UNITED STATES PATENT AND TRADEMARK OFFICE

10/776,487

Office Action Summary

DETAILED ACTION

Fig. 18

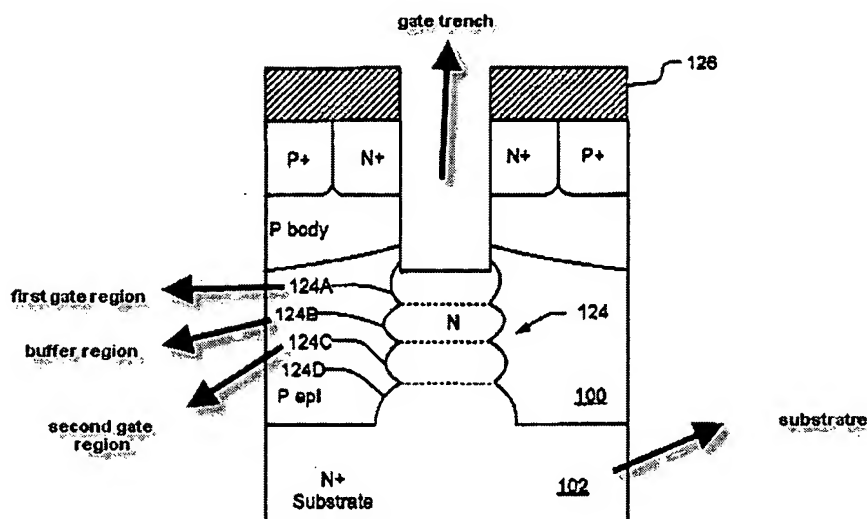
In re claim 21, **Darwish** discloses a method for fabricating a dual gate structure for a field effect transistor (FET), the method comprising: in sequence, etching a gate trench in a surface of a semiconductor substrate **100, 102**; forming a first gate region **124A** at the bottom of the gate trench; implanting a buffer region 124B beneath the first gate region **124A**; and implanting (see col. 9, lines 2-19 and FIGS. 17A-B and 18) a

second gate region **124C** beneath the buffer region **124B**, wherein the second gate region **124C** is formed entirely beneath the first gate region **124A**; wherein said first gate region **124A** and said second gate region **124C** together form said dual gate structure (see col. 7, line 55 to col. 8, line 10 and FIG. 18, for example).

In re claim 22, as applied to claim 21 above, Darwish discloses all claimed limitations including the limitation wherein the method further comprising forming a sidewall spacer to establish a width of the first gate region 124A (see FIG. 5G and 18, for example).

In re claim 23, as applied to claim 21 above, **Darwish** discloses all claimed limitations including the limitation wherein the method further comprising forming a sidewall spacer to establish a width of the buffer region **124B** (see FIG. 5G and 18, for example).

In re claim 24, as applied to claim 21 above, Darwish discloses all claimed limitations including the limitation wherein the method further comprising forming a sidewall spacer to establish a width of the second gate region **124C** (see FIG. 5G and 18, for example).

Fig. 18

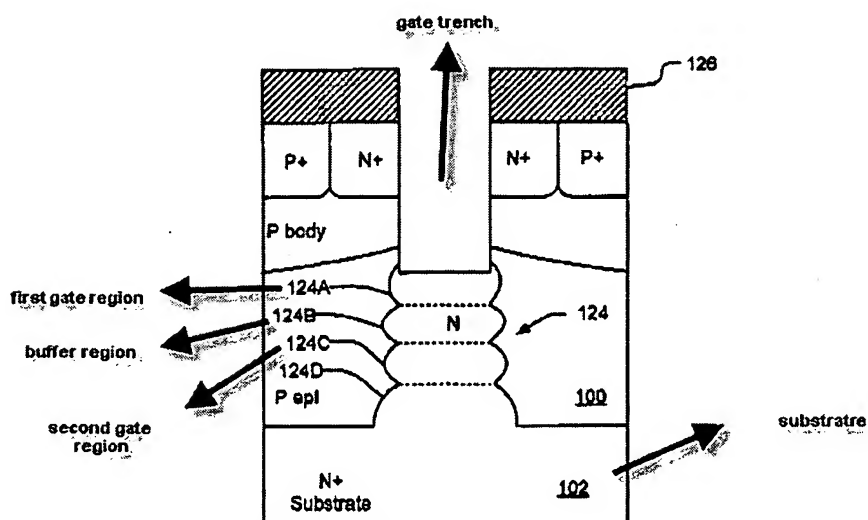
In re claim 26, Darwish discloses a method for fabricating a dual gate structure for a field effect transistor (FET), the method comprising: etching a gate trench in a surface of a semiconductor substrate **100**, **102**; forming a first gate region **124A** at the bottom of the gate trench, implanting a buffer region **124B** beneath the first gate region **124A**; and implanting (see col. 9, lines 2-19 and FIGS. 17A-B and 18) a second gate region **124C** beneath the buffer region **124B**, wherein the second gate region **124C** is formed entirely beneath the first gate region **124A**; wherein said first gate region **124A** and said second gate region **124C** together form said dual gate structure (see col. 7, line 55 to col. 8, line 10 and FIG. 18, for example).

In re claim 27, as applied to claim 26 above, Darwish discloses all claimed limitations including the limitation wherein the method further comprising forming a sidewall spacer to establish a width of the first gate region 124A (see FIGS. 5G and 18, for example).

In re claim 28, as applied to claim 26 above, Darwish discloses all claimed limitations including the limitation wherein the method further comprising forming a sidewall spacer to establish a width of the buffer region 124B (see FIGS. 5G and 18, for example).

In re claim 29, as applied to claim 26 above, Darwish discloses all claimed limitations including the limitation wherein the method further comprising forming a sidewall spacer to establish a width of the second gate region 124C (see FIGS. 5G and 18, for example).

Fig. 18

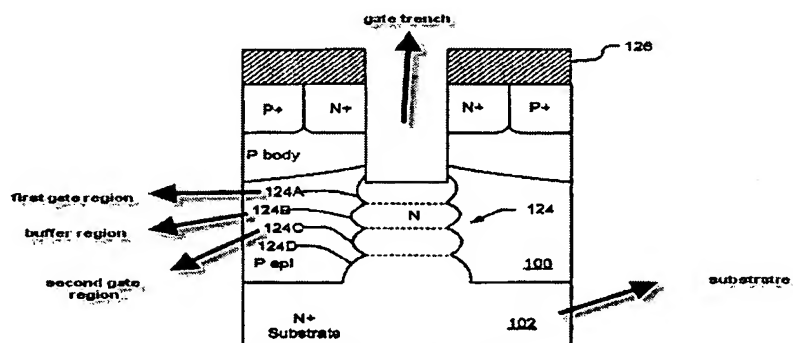
In re claim 30, Darwish discloses a method for fabricating a dual gate structure for a field effect transistor the method comprising: etching a gate trench in a surface of a semiconductor substrate 100, 102 (see FIG. 18);

forming a first gate region **124A** at the bottom of the gate trench; implanting a buffer region **124B** beneath the first gate region **124A**; and after implanting the buffer region **124B**, implanting (see col. 9, lines 2-19 and FIGS. 17A-B and 18) a second gate region **124C** beneath the buffer region **124B**, wherein said second gate region **124C** is formed entirely beneath said first gate region **124A**; wherein said first gate region **124A** and said second gate region **124C** together form said dual gate structure (see col. 7, line 55 to col. 8, line 10 and FIG. 18, for example).

In re claim 31, as applied to claim 30 above, Darwish discloses all claimed limitations including the limitation wherein the method further comprising forming a sidewall spacer to establish a width of the first gate region **124A** (see FIGS. 5G and 18, for example).

In re claim 32, as applied to claim 30 above, Darwish discloses all claimed limitations including the limitation wherein the method further comprising forming a sidewall spacer to establish a width of the buffer region **124B** (see FIGS. 5G and 18, for example).

In re claim 33, as applied to claim 30 above, Darwish discloses all claimed limitations including the limitation wherein the method further comprising forming a sidewall spacer to establish a width of the second gate region **124C** (see FIGS. 5G and 18, for example).

In re claim 34, as applied to claim 30 above, Darwish discloses all claimed limitations including the limitation wherein the method further comprising forming a first sidewall spacer to establish a width of the buffer region **124B**, and forming a second

sidewall spacer to establish a width of the second gate region **124C**, wherein the second sidewall spacer is thicker than the first sidewall spacer (see FIGS. 5G and 18, for example).
